Co3237 Poultney BF 0145(13)

ADDENDUM #1

- Invitation for Bids, and Proposal to extend Bid Opening to June 13, 2025, and update the Schedule of Items.
- Special Provision Pages 1 and 6.
- Plan sheets 3, 10, 11, 44-52, 57, 63, 65, 79-82, 93, 94, 96, and 97.
- New Impact Plans shall replace Pages 136 to 171 in the Proposal.

SCALE 1 1/2"=1'-0"

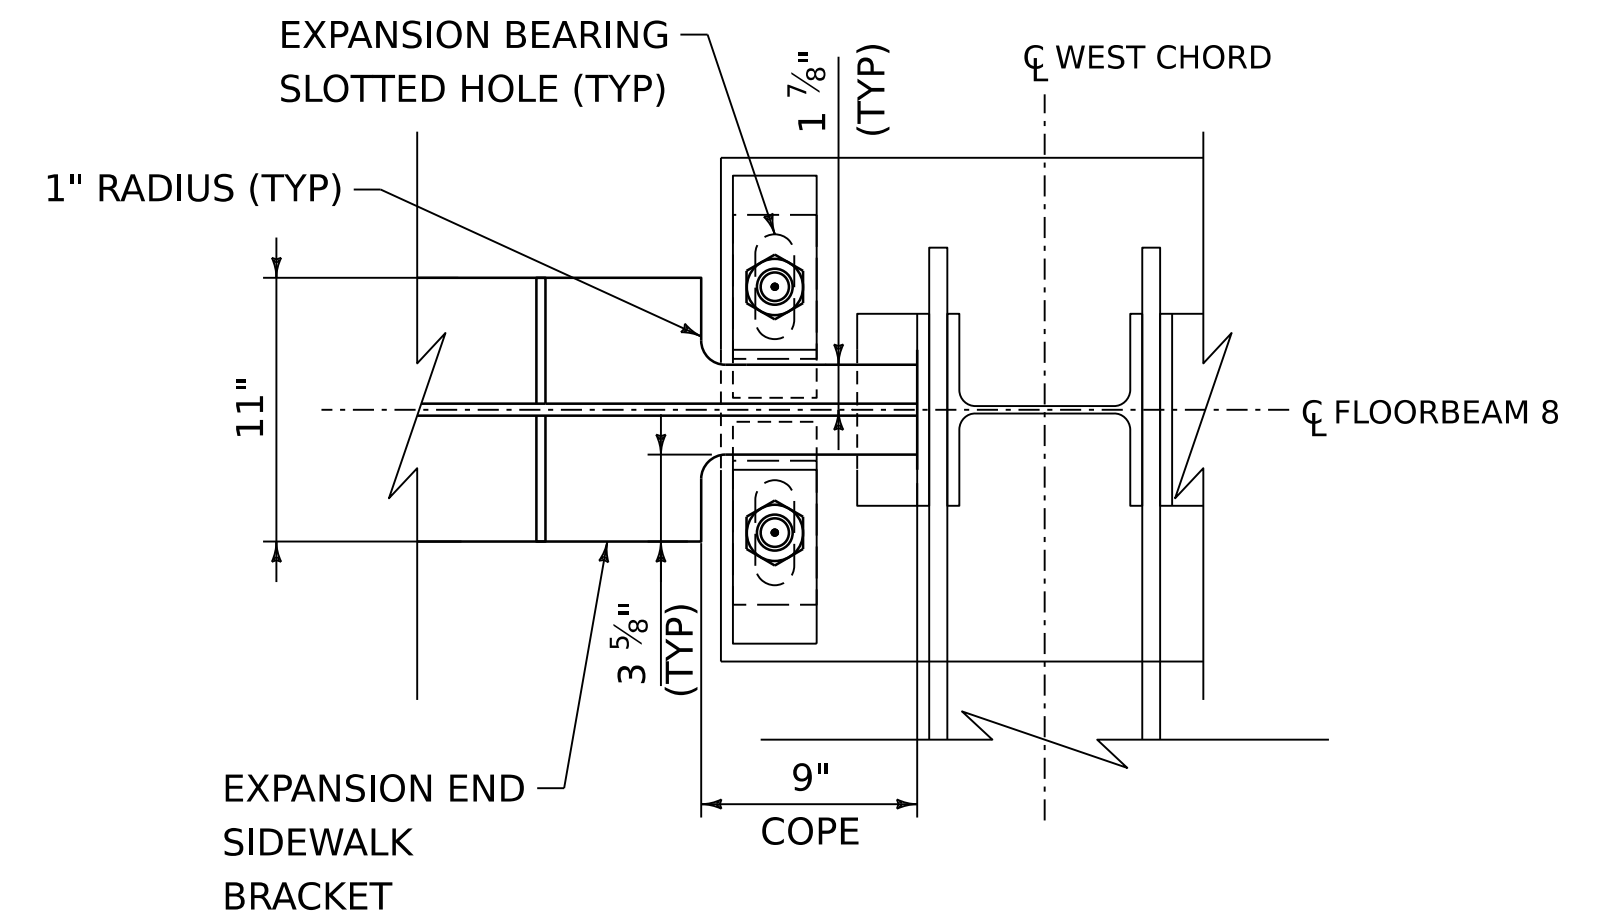
ADDENDUM	REVISION	PLOT DATE	DESCRIPTION	BY
1	1	5/19/2025	REVISED STRINGER CONNECTIONS AND SHEAR STUDS	NAT

FILE NAME: z21j164sidewalk.dgn
PROJECT LEADER: J.D. KEENER
DESIGNED BY: N.A. TRUSLOW
SIDEWALK STRINGER DETAILS

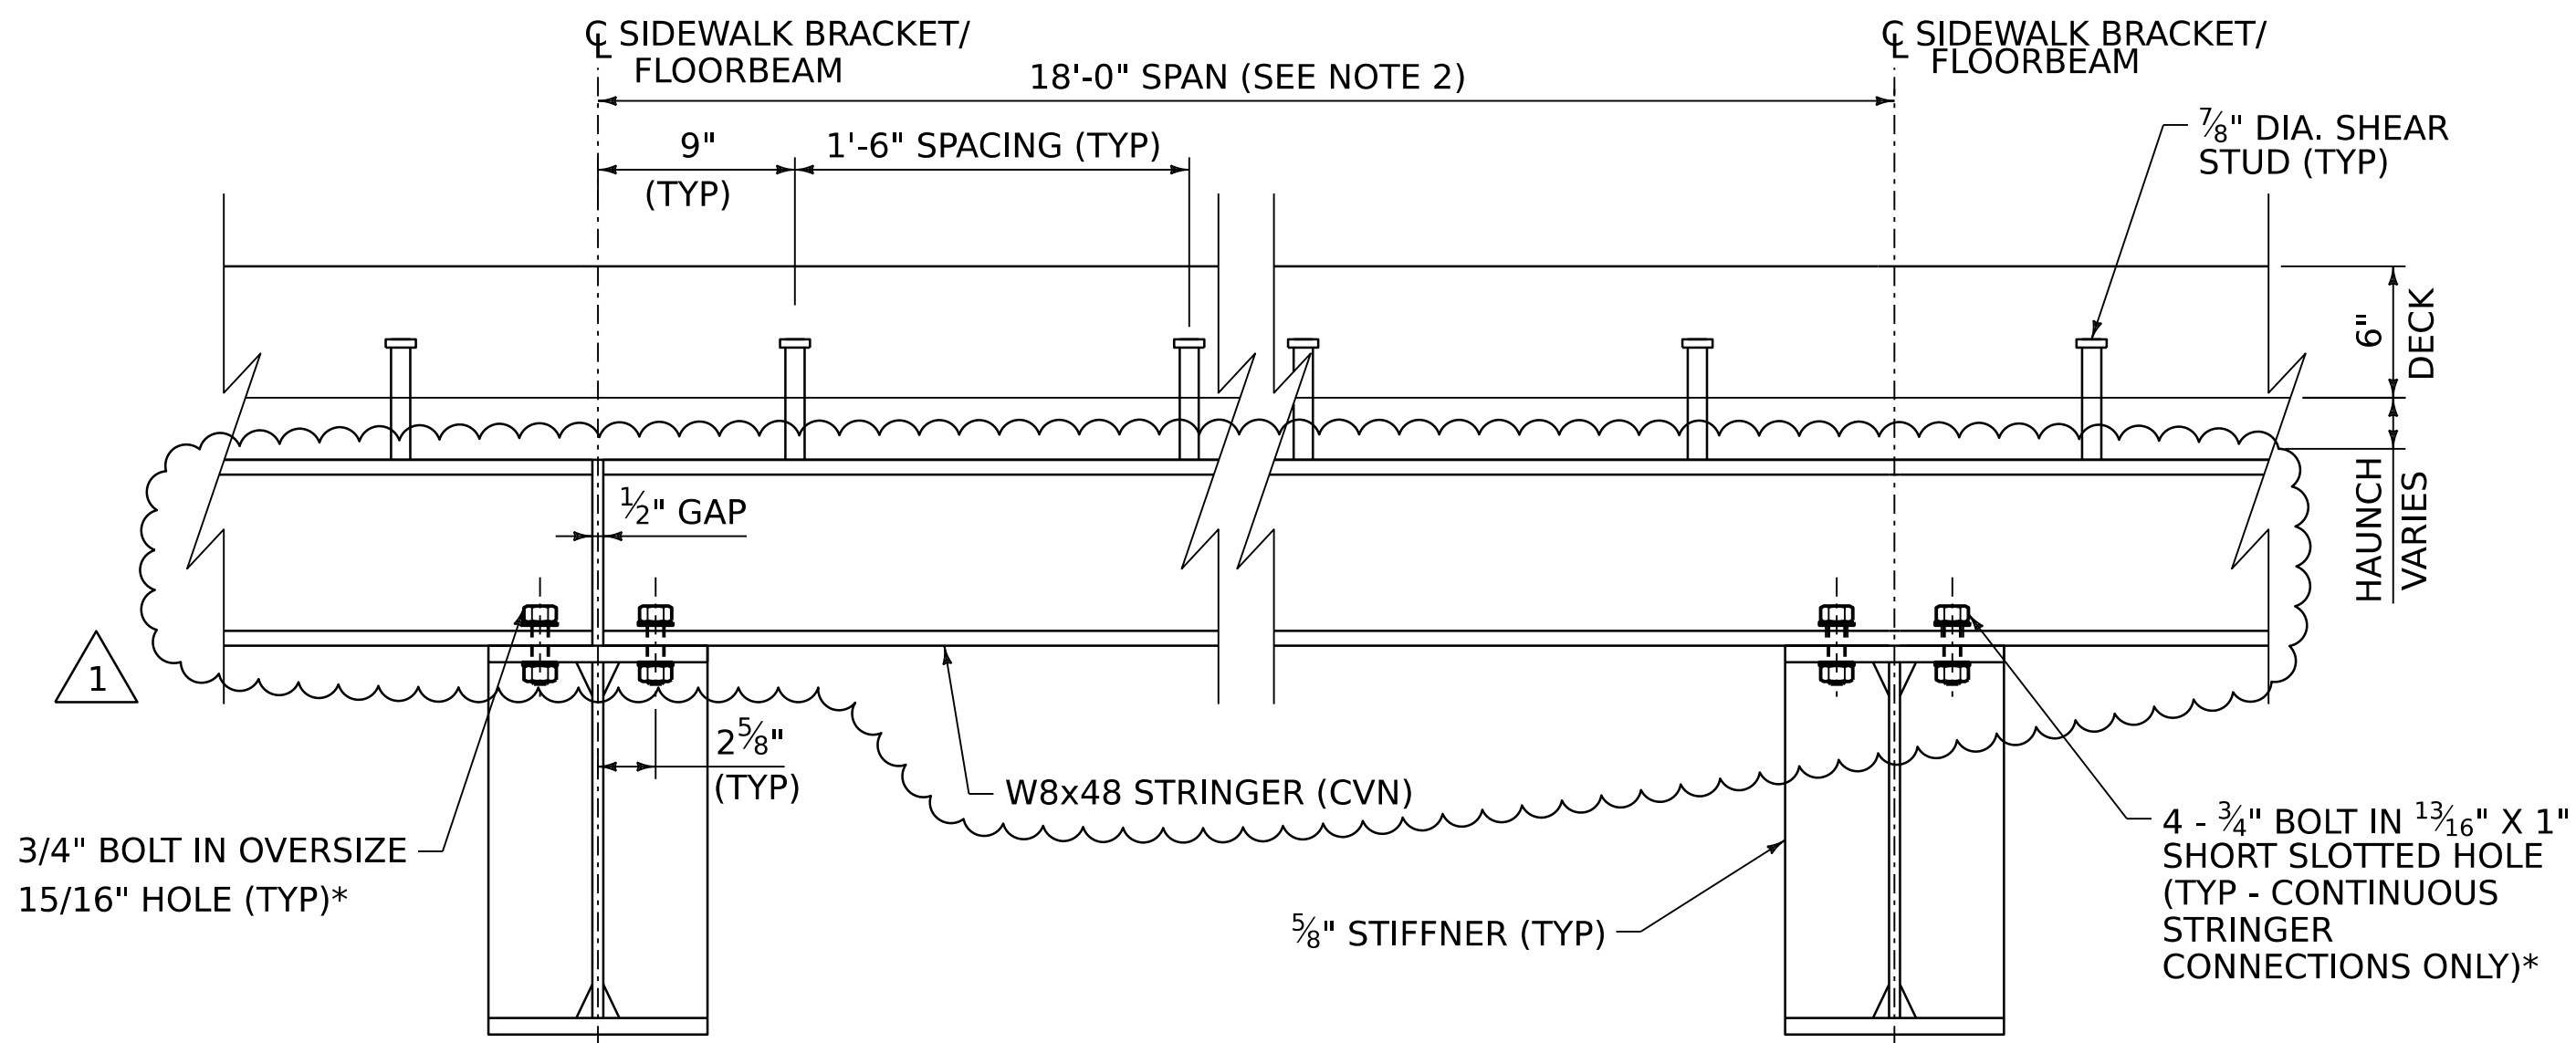
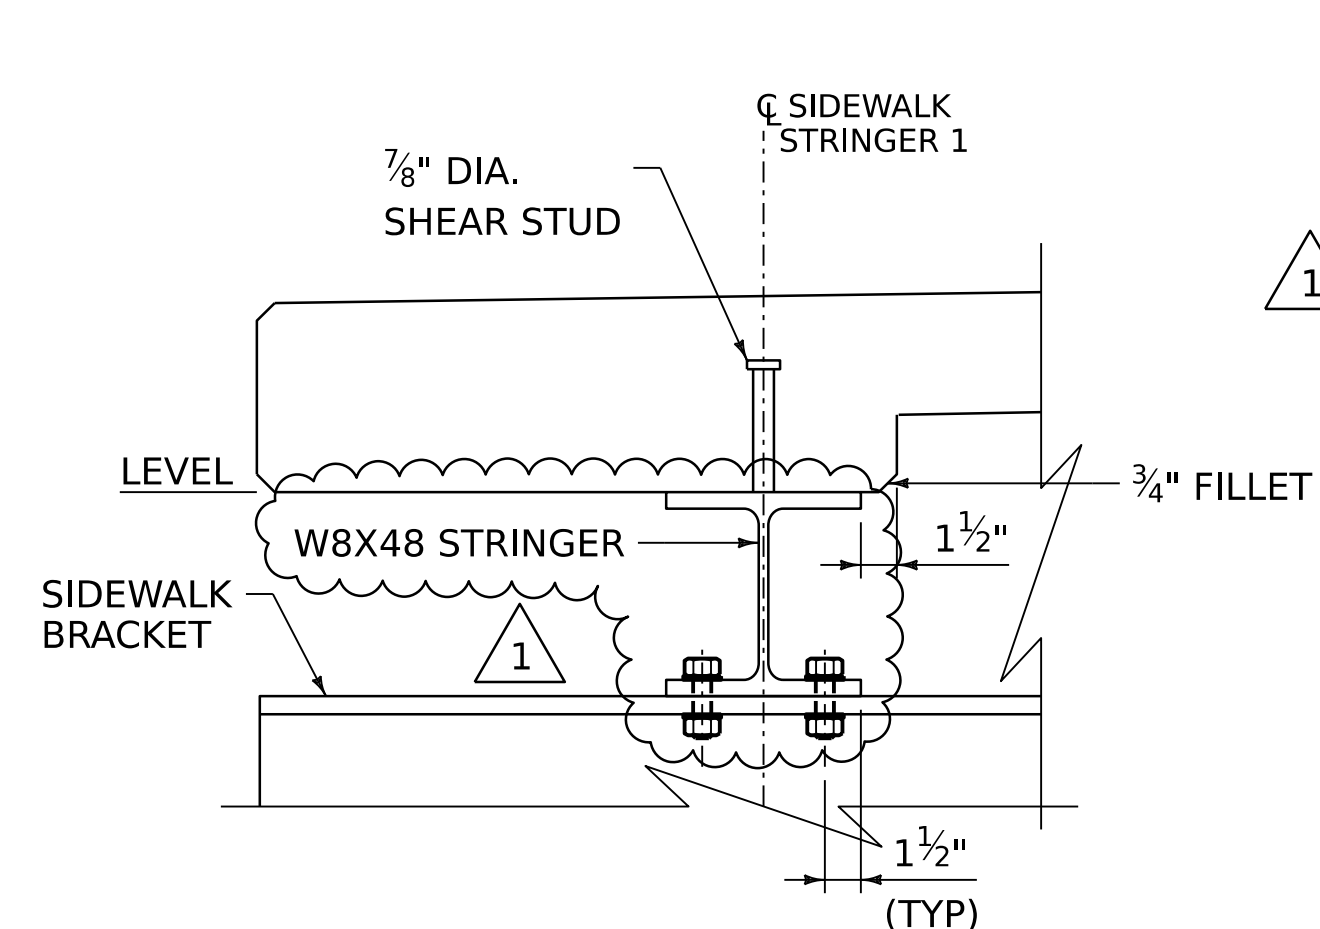
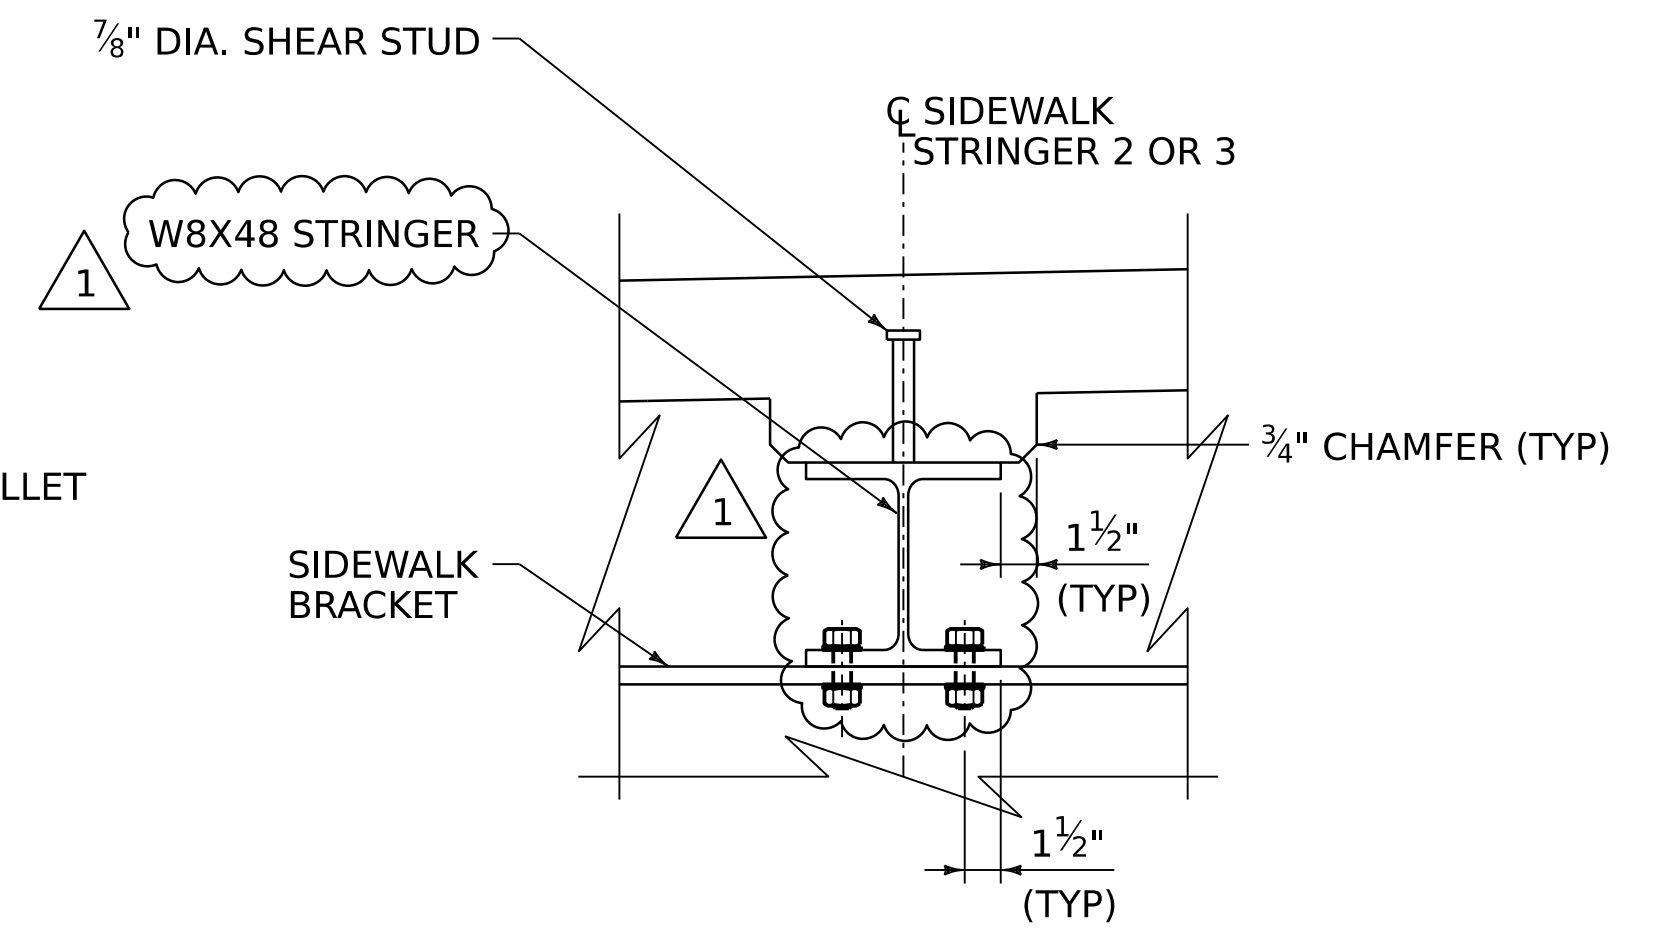
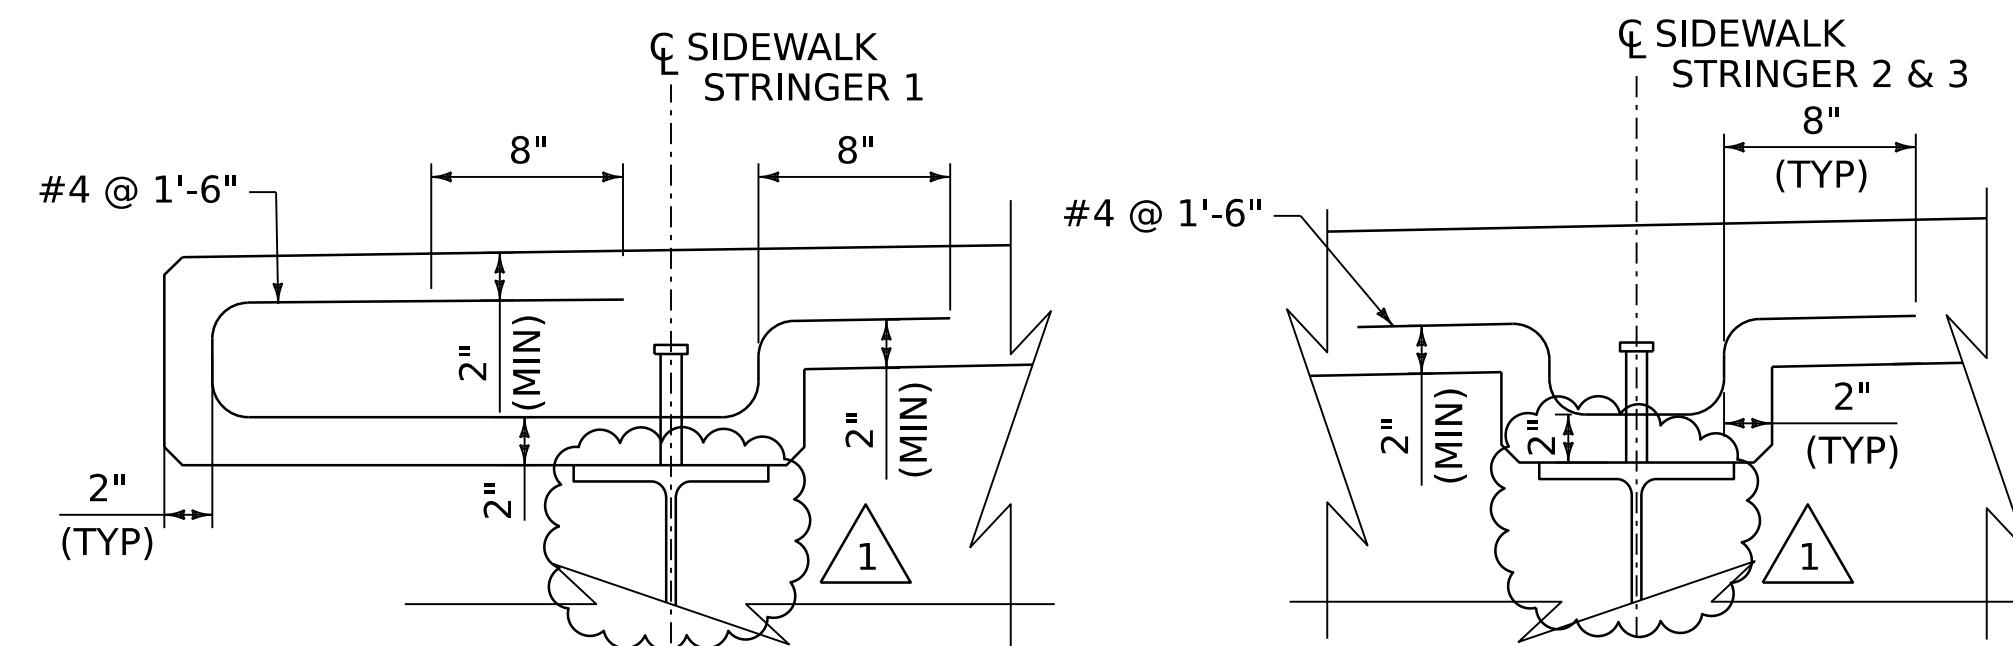
ADDENDUM	REVISION	PLOT DATE	DESCRIPTION	BY
1	1	5/19/2025	CHANGED STRINGERS TO W8X48	MSWT

PROJECT NAME: POULTNEY	
PROJECT NUMBER: BF 0145(I3)	
FILE NAME: z21j164pedrail.dgn	PLOT DATE: 5/19/2025
PROJECT LEADER: J.D. KEENER	DRAWN BY: M.S.W. THISTLE
DESIGNED BY: N.A. TRUSLOW	CHECKED BY: VHB
PEDESTRIAN FENCE DETAILS	SHEET 79 OF 115

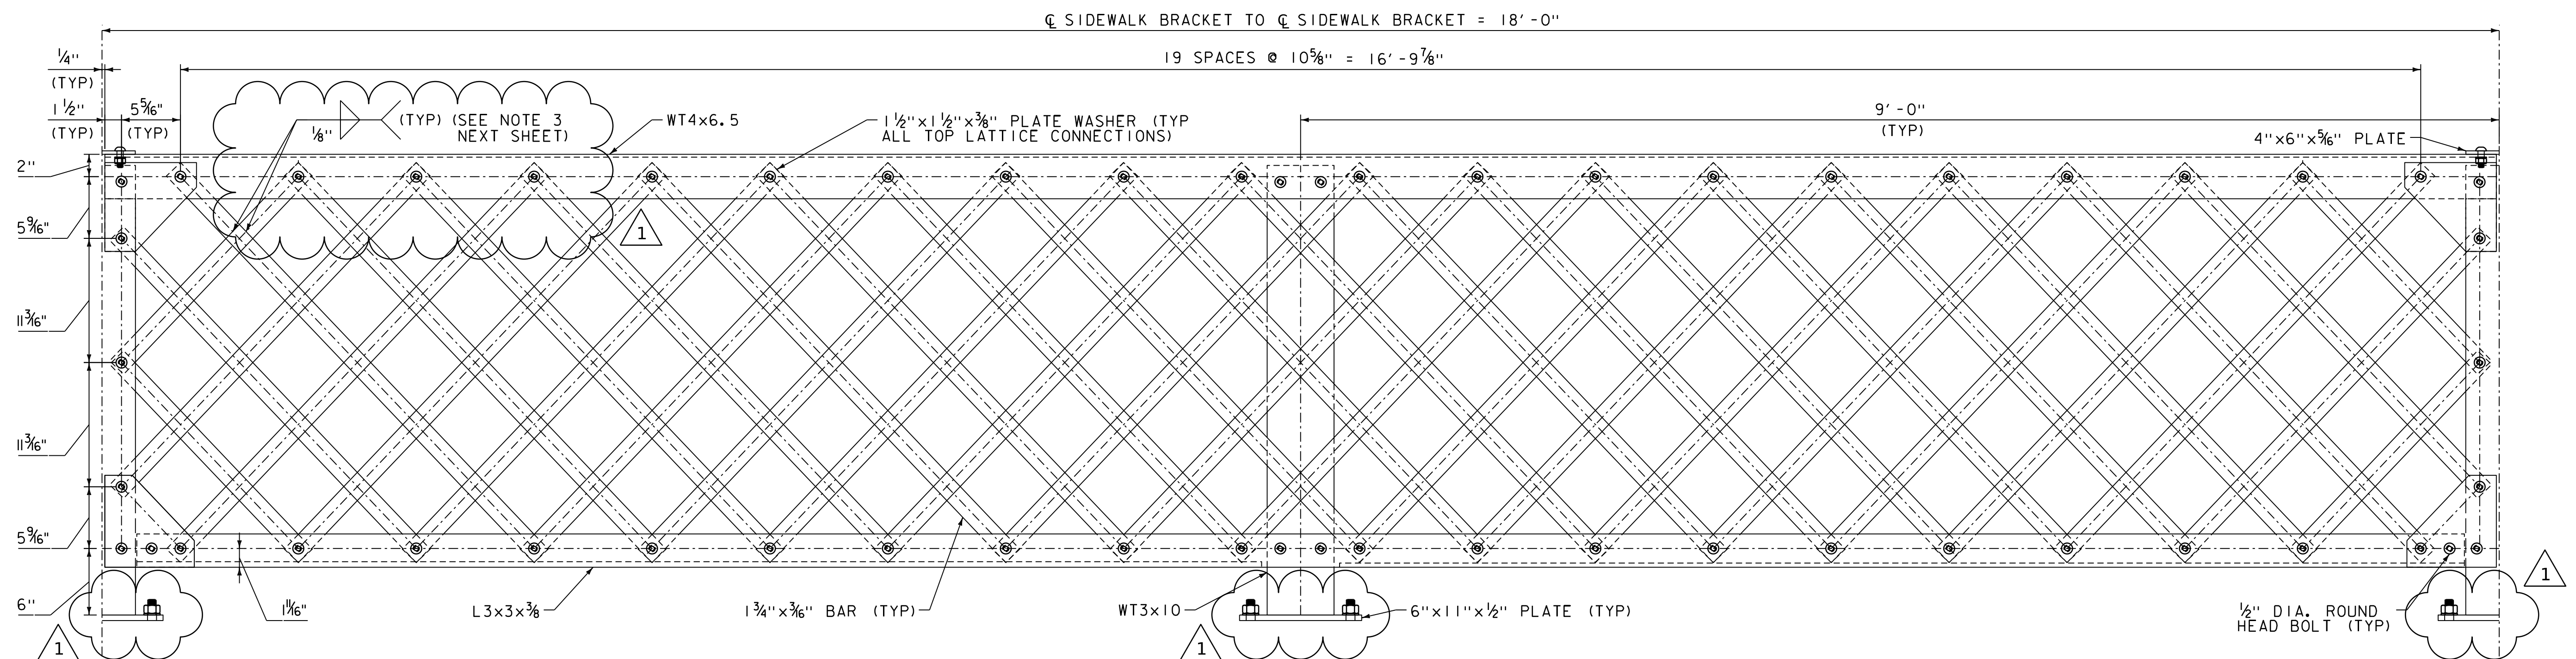
ADDENDUM	REVISION	PLOT DATE	DESCRIPTION	BY
1	1	5/19/2025	ADDED FENCE TRANSITION DETAIL, UPDATED NOTES	MSW
